Access Compliance Report Public Rights-of-Way (Curb Ramps)

Main Street: 17TH_ST Cross Street: WINDSOR_PL Location: SE

ADA ID: RPRK211008123927 Ramp Type: Type 6 - Directional 1 Initial Pass/Fail: Fail Overall Compliance: No Severity Score: 15

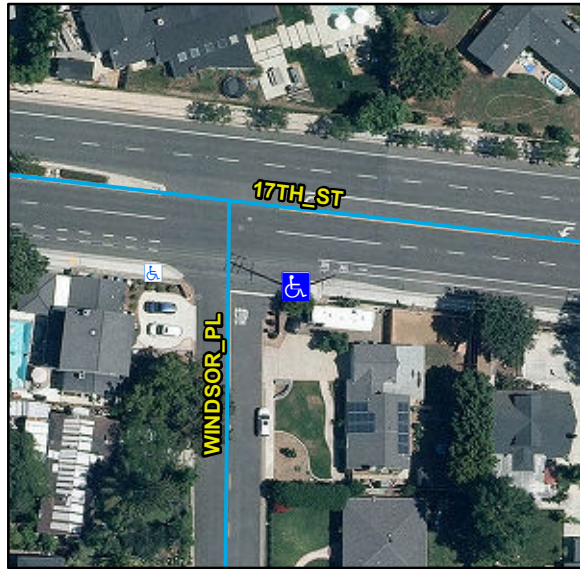
Compliance	Description	Data	Compliance	Description	Data
N/A	Ramp Length (in)	102	N/A	Flare Type LT	
Yes	Ramp Width (in)	48			N/A
No	Ramp Run Slope (%)	11.2	N/A	Flare Slope LT (%)	N/A
Yes	Ramp Cross Slope (%)	3.3	N/A	Flare Traversable LT	N/A
N/A	Grade Break	N/A	N/A	Flare Type RT	
N/A	Grade Break Slope (%)	N/A			N/A
N/A	Grade Break Cross Slope (%)	N/A	N/A	Flare Slope RT (%)	N/A
	Addl Para Ramp Left?	No	N/A	Flare Traversable RT	N/A
	Addl Para Ramp Right?	No	N/A	DWS Provided	N/A
N/A	Landing Present	N/A	N/A	DWS Contrast	N/A
N/A	Landing Length (in)	N/A	N/A	DWS Length (in)	N/A
N/A	Landing Width (in)	N/A	N/A	DWS Full Width	N/A
N/A	Landing Run Slope (%)	N/A		DWS Offset Type	N/A
N/A	Landing Cross Slope (%)	N/A	N/A	DWS Left Offset (in)	N/A
N/A	Landing Movement Obstructed?	N/A	N/A	DWS Right Offset (in)	N/A
	Landing Movement Type	N/A			
N/A	Landing Shared	N/A			
N/A	Marked Crosswalk 1	No	N/A	Clear Space	Yes
	Crossing 1 Direction	N	N/A	Clear Space To Crosswalk (in)	N/A

Marked Crosswalk 1 Width (in)	N/A			
N/A	Ramp Inside Crosswalk 1	N/A			
	Crossing 1 Slope (%)	2.5			
	Crossing 1 Cross Slope (%)	5.3			
N/A	Gutter Ponding	N/A	N/A	Curb Slope	11.7
Yes	Gutter Lip Height (in)	0		Road Run Slope (%)	5.4
N/A	Gutter Run Slope (%)	N/A		Road Cross Slope (%)	3.5
N/A	Gutter Cross Slope (%)	N/A		Parallel Ramp Side	N/A
Yes	Overall Surface Condition	Acceptable	Yes	Perp Joint Present	Yes
	Cross Gutter Present?	No		Spandrel Present?	No
	Replace Cross Gutter?	N/A		Replace Spandrel?	N/A

Remove & Replace Curb Ramp With Two New Directional Ramps or Equivalent.
